Cedar City

CITY COUNCIL WORK MEETING
JULY 21, 2021
5:30 P.M.

**CEDAR CITY
CITY COUNCIL AGENDA ITEM 21
STAFF INFORMATION SHEET**

SHED NO.
R6
FILE
R06

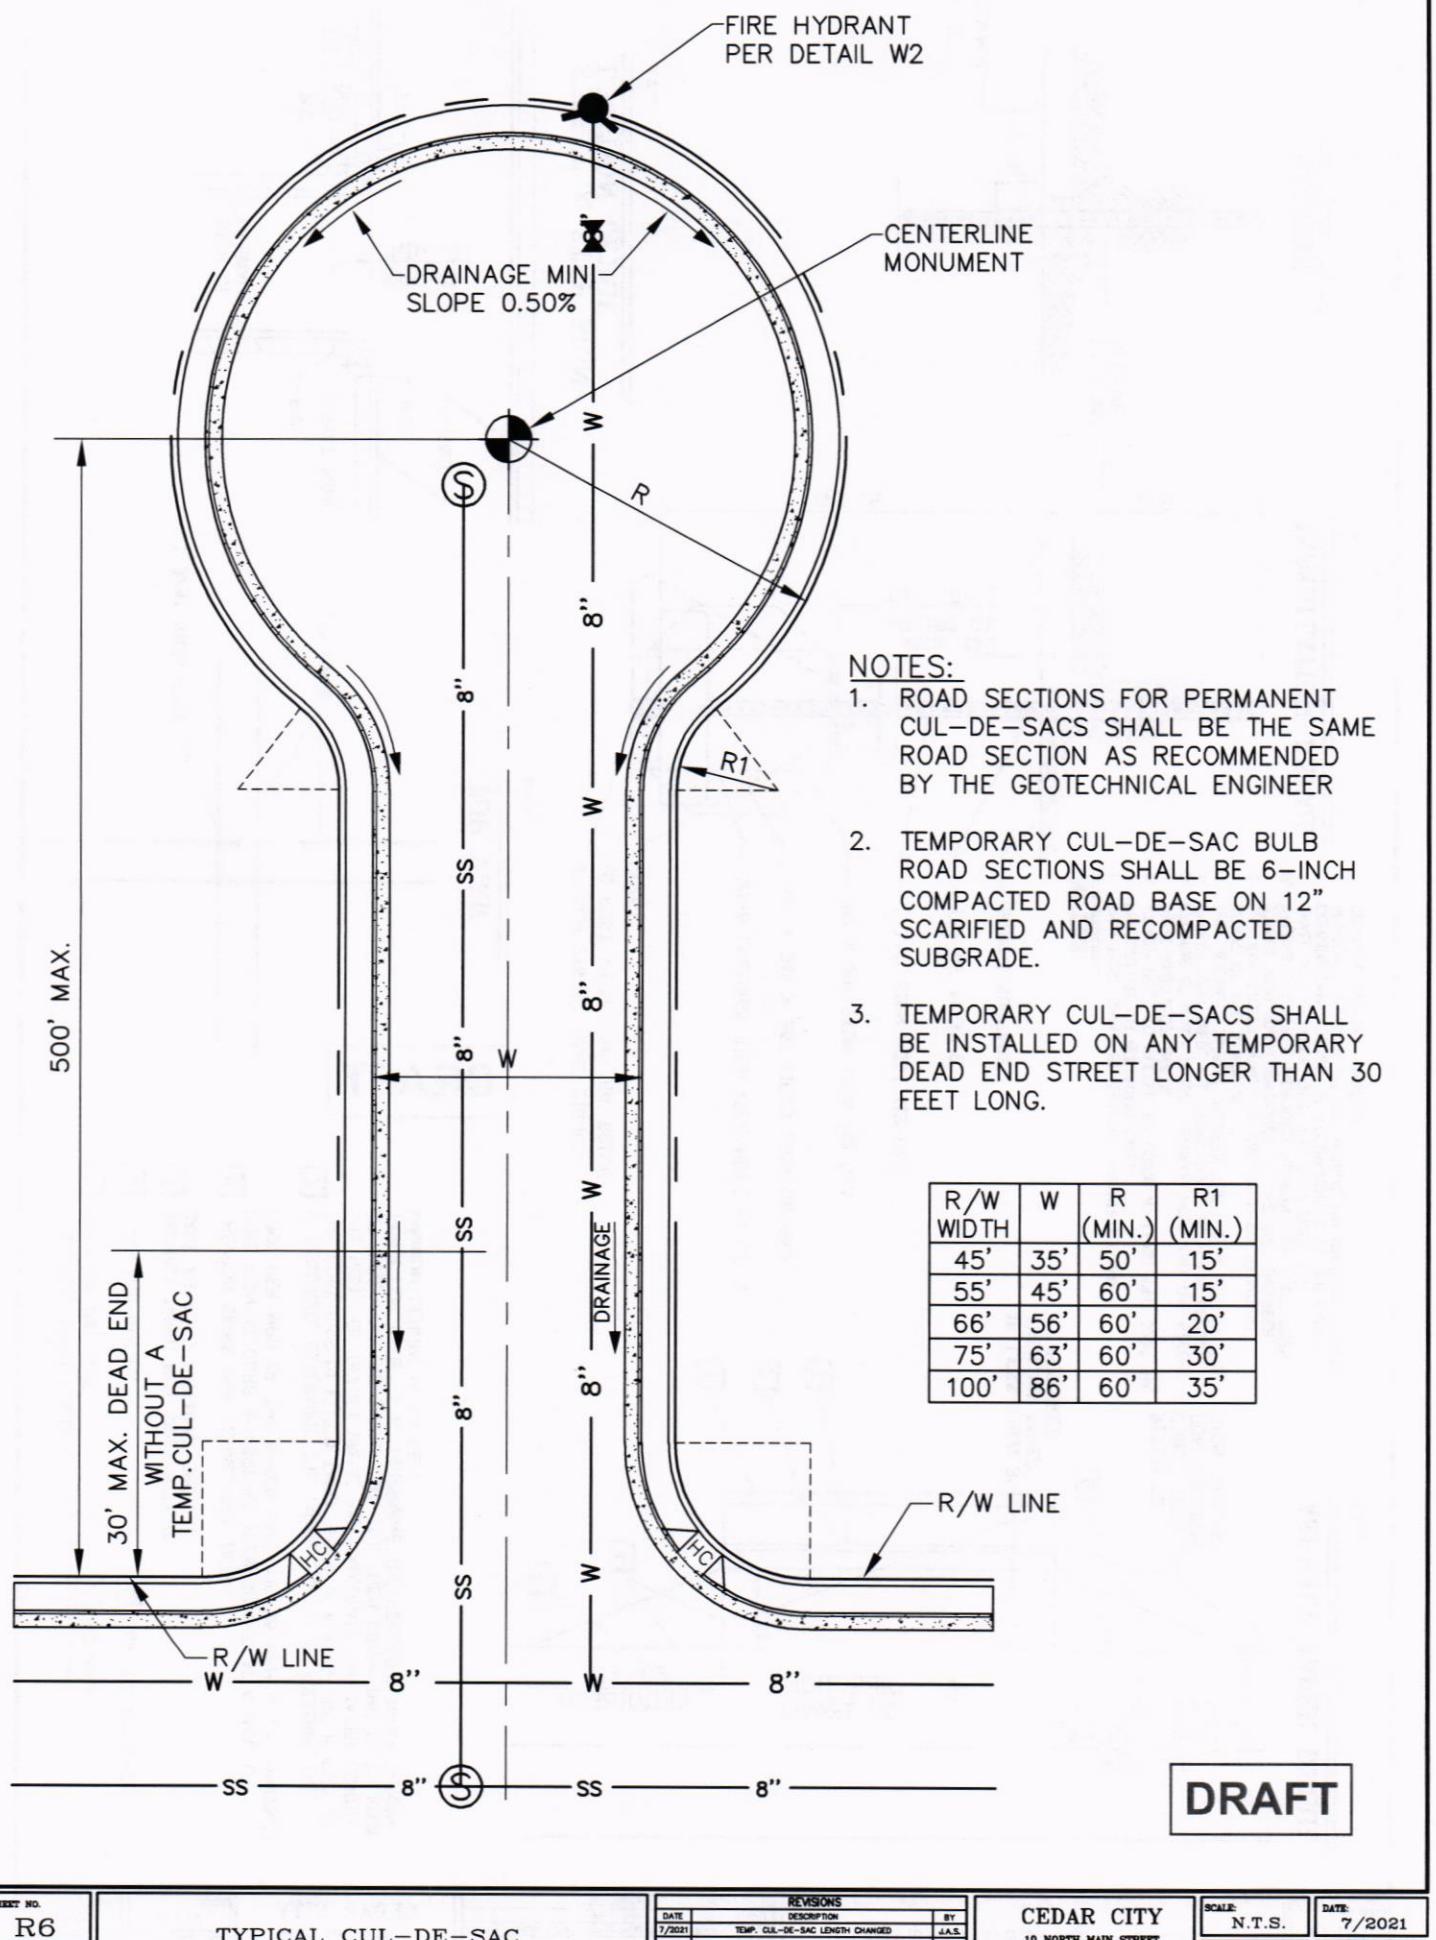
19	Detail R6	The maximum dead-end length without a temporary cul-de-sac was reduced from 100 feet to 30 feet.	Public Works	Increase

Detail R-6: on the cul-de-sac detail there is 1 change; they currently require if the length of the dead end is longer than 100' that they have a temporary cul-de-sac. They have run into issues with drive locations on these and they have no where to turn the plow around. They propose to shorten that distance of a dead-end to 30' and then they make sure they have a way to turn those plows and emergency vehicles around. For temporary, it only needs to be gravel.

SHET NO.
S3
FILE: S03

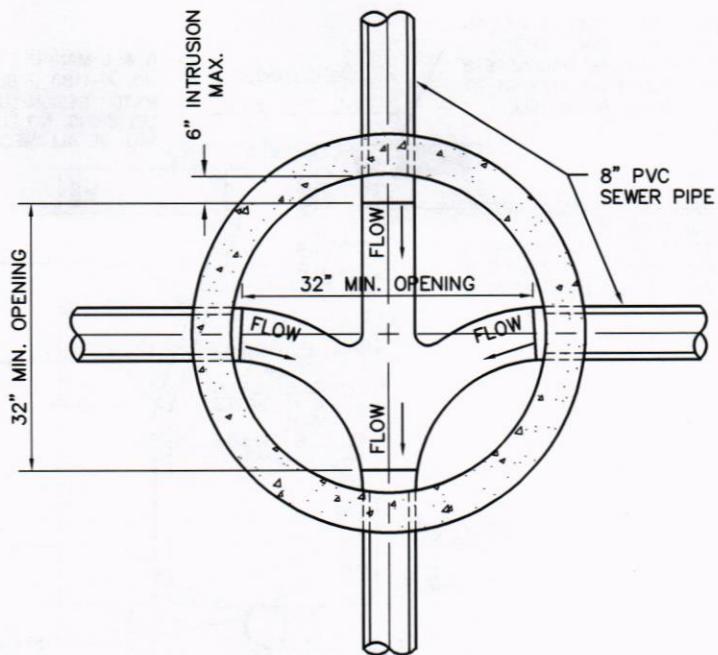
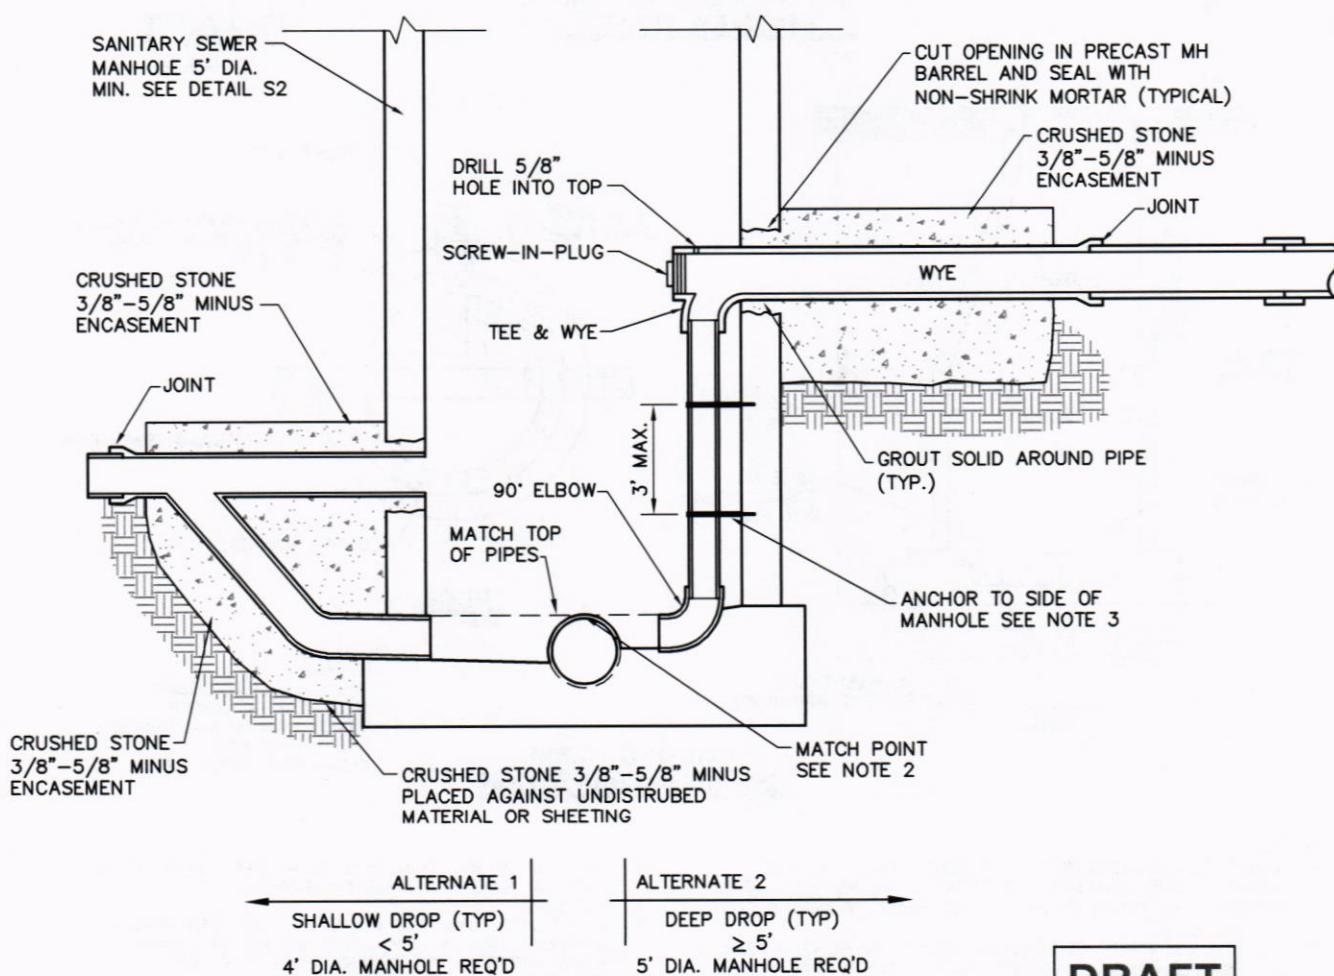
Removed the notes showing a 2-inch conduit going into the manhole. Conduits need to terminate behind sidewalk in a junction box.	Sewer	Increase (City)
24	Detail S3	Changed the concrete encasement to crushed stone encasement. Deleted the brick dam in the shallow drop. Added a note that the maximum pipe intrusion into the manhole is 6 inches. Also, added a note that the minimum opening width inside the manhole is 32 inches.	Sewer	Decrease Decrease No change

Detail S-3: the concrete drop manhole detail. There are a few changes: 1 is to delete the concrete encasement around the manhole and now calls out as sand slurry. The sewer division prefers crushed stone and that is a change. currently brick dam they are showing and are planning to delete that. The pipe intrusion showing 6" and the minimum width opening of 32" is for the camera.

REVISIONS
DATE: 7/2021
DESCRIPTION: ADDED DETAIL W1A
BY: J.A.S.

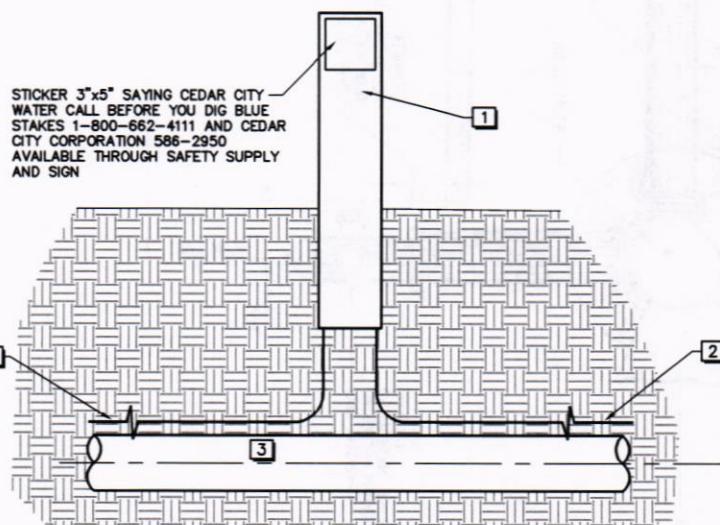
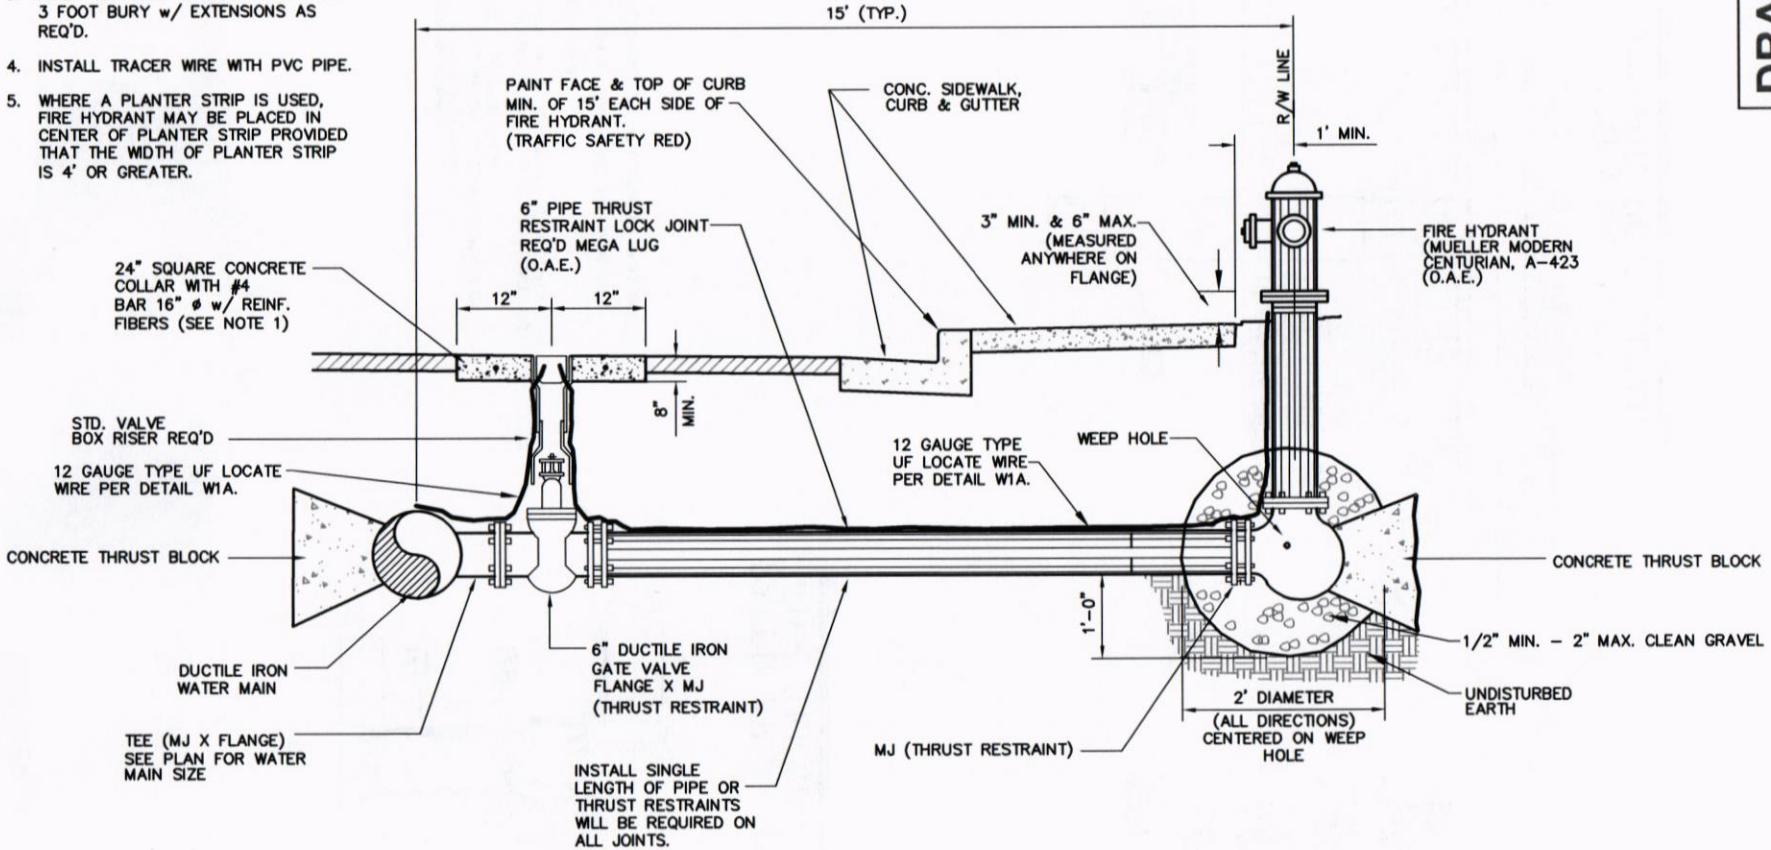
29	Detail W1A	This detail was added to show the details for tracer wire that needs to be used with PVC waterlines.	Public	Decrease (PVC pipe)
30	Detail W2	Note added to install tracer wire into the hydrant valve can and show tracer wire along the hydrant line.	Public	Decrease (PVC pipe)
		Note added regarding fire hydrant location with a planter strip.	Engineering	No change
31	Detail W3	Added a note stating that proper mega-lugs must be used to prevent damage to PVC pipe.	Public	Decrease (PVC pipe)
32	Detail W4	Mega-lugs added on outside of vault at pipe penetrations in order to prevent pipe movement. Ductile iron pipe required to 10 feet outside vault.	Water	Increase
		Pressure relief pipe added. This will allow PVC water mains to be installed downstream of PRV's.	Water	Increase
		Added 2 additional leveling jacks to support the pipe.	Water	Increase
		Added a note clarifying that all pipe materials need to be rated for water system pressure.	Water	No change

Detail W1A- is the last one; this is to allow the PVC 900 water line pipe. They only allowed DI pipe and he did research to allow them to use the PVC and this will decrease costs.

SECTION NO.
W7
FILE: W07

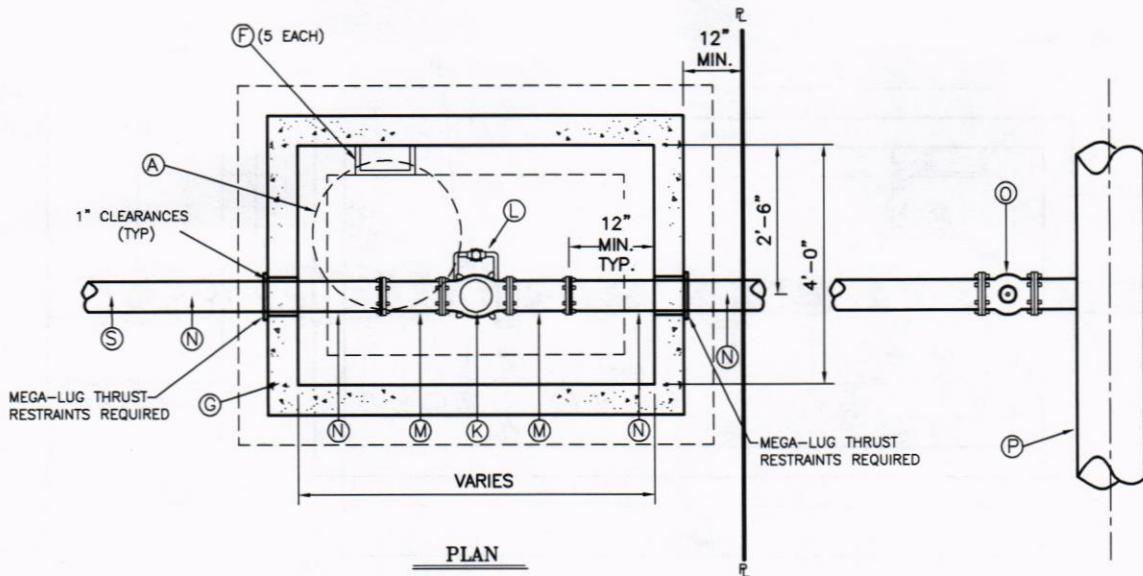
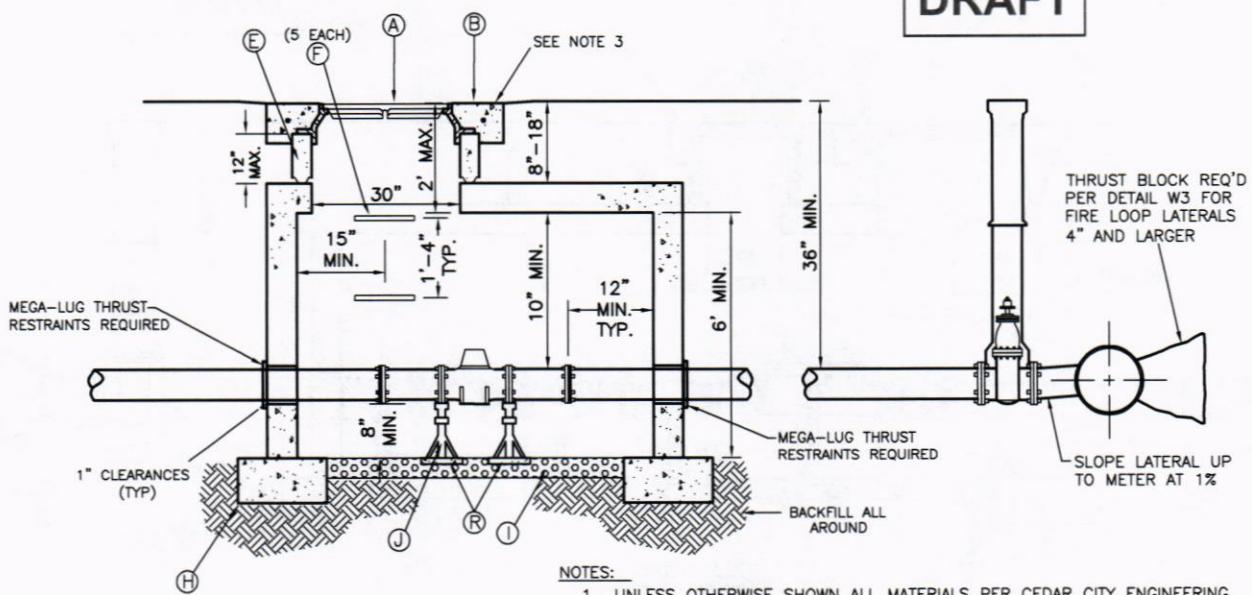
35	Detail W7	Mega-lugs added on outside of vault at pipe penetrations in order to prevent pipe movement. Ductile iron pipe required to 10 feet outside of vault.	Water	Increase
		Strainer added downstream of the PRV (if a PRV is required). The strainer will be purchased from the City. Valve added downstream of the backflow assembly.	Water	Increase
		Added 3 additional leveling jacks to support the pipe.	Water	Increase
		Added a note clarifying that all pipe materials need to be rated for water system pressure. Note added that only NFPA 13R fire sprinkler systems are allowed with this detail. Note added that fire sprinkler systems should be designed according to reduced pressure when using a PRV in the vault.	Water	No change
36	Detail W8	Mega-lugs added on outside of vault at pipe penetrations in order to prevent pipe movement. Ductile iron pipe required to 10 feet outside of vault.	Water	Increase
